Application No.: 10/703,390
Applicant: van den Brink et al.
Docket No.: 903-91 PCT/US/CIP
Page 8

Amendments to the Drawings:

A SYSTEM FOR PERFORMING EXPERIMENTS, IN PARTICULAR FOR HIGH THROUGHPUT EXPERIMENTATION

Annotated Sheet Showing Changes

Fig 2

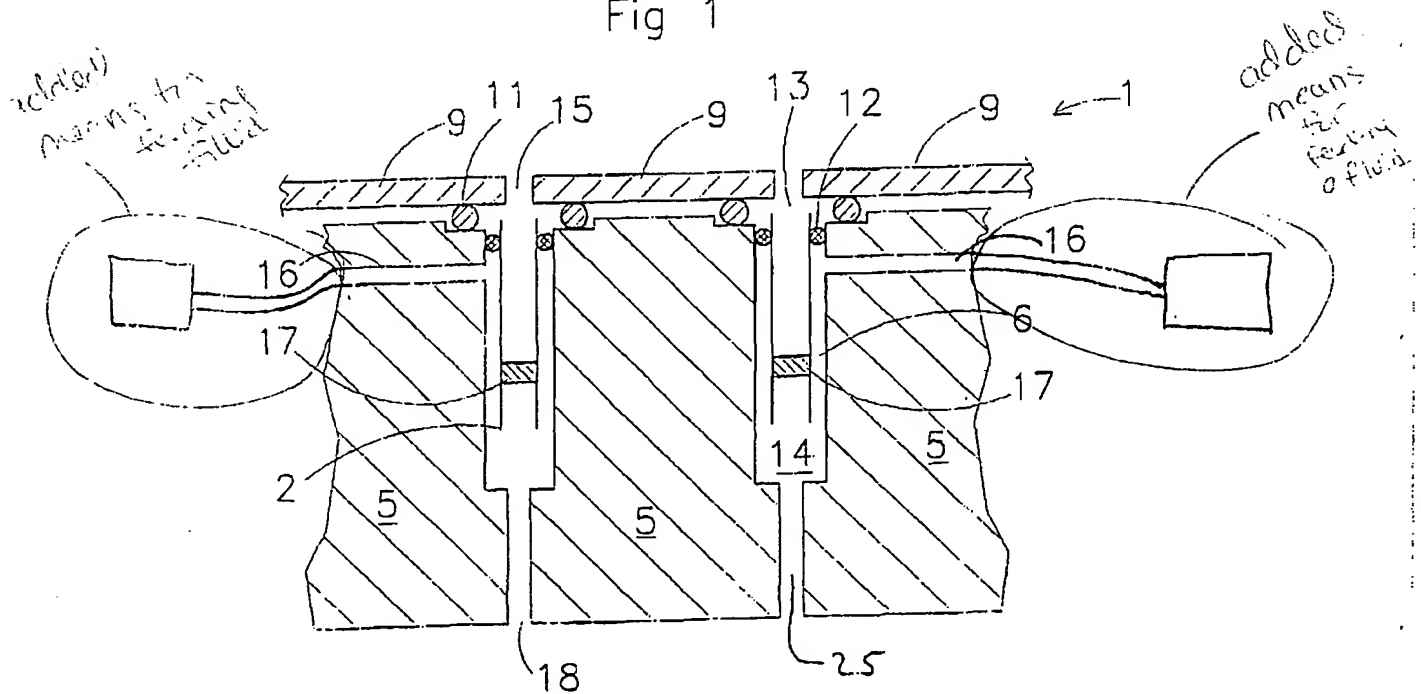
The Figures 2 and 3 on attached replacement sheets 1/3 and 2/3 have been changed. In Figure 2 previously omitted means for feeding fluid has been added. In Figure 3 previously omitted means for feeding fluid has been added. No new matter is introduced with these amendments.

The drawings were objected to 35 under 37 CFR 1.83(a) as allegedly not showing the means for feeding a fluid via the fourth channel. The means for feeding fluid via the fourth channel is described in the specification at par.[0031], [0063] – [0065]. The means for feeding fluid via the fourth channel 16 has been added to Figures 2 and 3 of Replacement Sheet 1/3 and 2/3. No new matter is introduced with these amendments.
